Development of Piccadilly Station

Development of Piccadilly Station Final Report

For: Manchester City Council

Document No. 26273-BEC-GE-TT-00001

Figure 2 – HS2 Limited Surface Station Track Layout showing signalling scheme assumed for simulation (2 island and 2 side platforms variant)

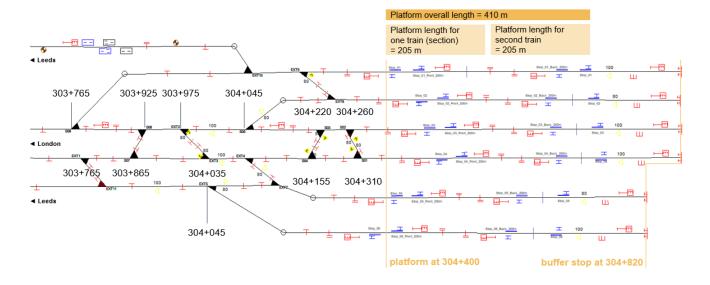
The results show that for both the surface and underground station options a conflict free timetable could be compiled. However, a number of observations and conditions to achieve the conflict free timetable were identified as follows:

Figure 4 shows that the surface station option is at capacity and Figure 5 that the underground station is slightly over capacity. Both options are compliant for the occupation rationale: that is, they both offer an ability to accommodate the required timetable, which in the absence of delays would in both cases work. In essence this means that whilst a conflict free timetable can be produced for both options, the underground option will be relatively more vulnerable to disruption arising from movement perturbations.

Figure 6 - Surface Station Restricted Headways

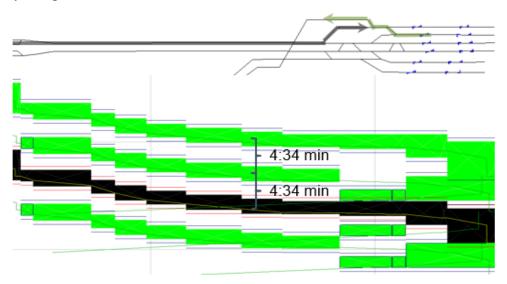
Within the surface station option certain headways are restricted by long reversals and crossing movements, as highlighted by the figure below.

It can be seen that for a train arriving at Manchester Piccadilly, followed by a departure to Leeds, the subsequent arrival from Manchester Airport has a potential headway of 4:34 minutes.

Figure 7 - Underground Station Restricted Headways

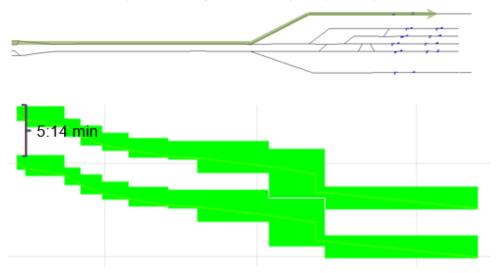
Similarly, for the surface station option, headway is restricted by one platform per direction.

As can be seen from the above figure the time interval between consecutive trains is 5:14 minutes, thus restricting the theoretical headway for the Manchester Spur.

Figure 18 - 2D schematic and indicative layout of HS2's surface concept.

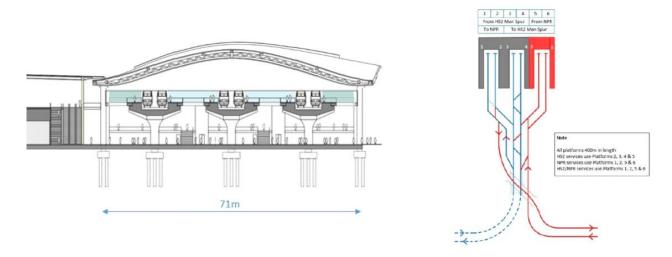
For the surface concept, HS2 Limited has included two additional 440 metre platforms for NPR turnback services at the same elevation as the HS2 station. This increases the width of the station to 71 metres and land-take on the northern flank by approximately 9,680 square metres, without consideration of the required wider station approach. The platform length does allow for occupation by two shorter 200m trains, which offers a measure of flexibility for future demand changes.

The surface concept benefits from a concourse that is shared between HS2 and NPR and is linked at the same elevation as the existing train shed. The shared main station entrance could offer an attractive city gateway, especially with the removal of Gateway House, which Greater Manchester believes to be required to deliver the current HS2 Limited proposal by providing an appropriate entrance sequence. However, a station on one level suffers from poor inter-connectivity as there is a minimum of two vertical transitions (one up and one down) for pedestrians to cross between platforms. Figure 18 shows a plan and a cross-section of the surface concept and Figure 19 highlights the additional land-take which results in encroachment on the regeneration area and which could also impact on the industrial heritage buildings in the area.

In both of HS2's options, the wholly surface option shown in Figure 18 and Figure 19, and the partially underground option, there is an opportunity to refine the station and canopy structure to improve its interaction with the planned boulevard and regeneration area. This might be achieved by cantilevering the outer edge of the station deck and providing a barrier-free incorporation of a partially covered boulevard running alongside and beneath. Further enhancement may be possible with coordinated design solutions for the station roof and adjacent boulevard buildings which would help avoid further set-back of the buildings and reduce the impact on the development land.

Figure 20 - 2D schematic and indicative layout of HS2's underground concept

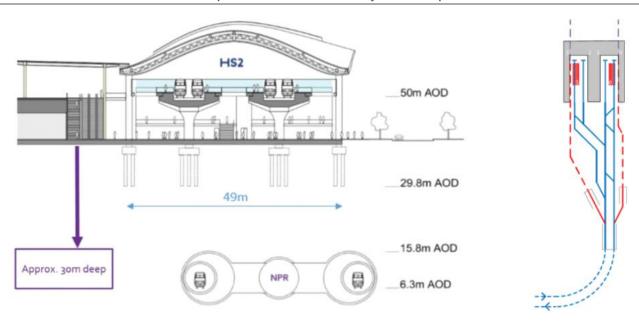
For the underground concept, HS2 Limited has included two additional 200 metre platforms for NPR through services directly below the HS2 surface station. This maintains the HS2 surface station width and therefore does not impact the regeneration area on the northern side. The *Strategic Regeneration Framework* and *Greater Manchester Growth Strategy* are predicated on an underground NPR station at Piccadilly. The underground platforms provide a through service towards Leeds with obvious operational benefits. However, 200 metre long platforms do not provide the same future proofing benefits as 400 metre platforms.

The underground concept could benefit from a shared HS2 and NPR concourse at the surface level, also with links to the existing station. Vertical circulation would be required to transition between surface level and the below ground NPR platforms. Underground cross connections between NPR platforms would be required to ease pedestrian inter-change movements.

As with the surface concept, the issues around interconnectivity between platforms at one level would still exist. The reduction in land-take when compared with the surface concept enables the boulevard to be situated further towards the existing train shed and gives more space for regeneration at surface. Figure 20 shows a plan and a cross-section of the underground concept and Figure 21 highlights the land-take of HS2's surface station and underground through NPR services.
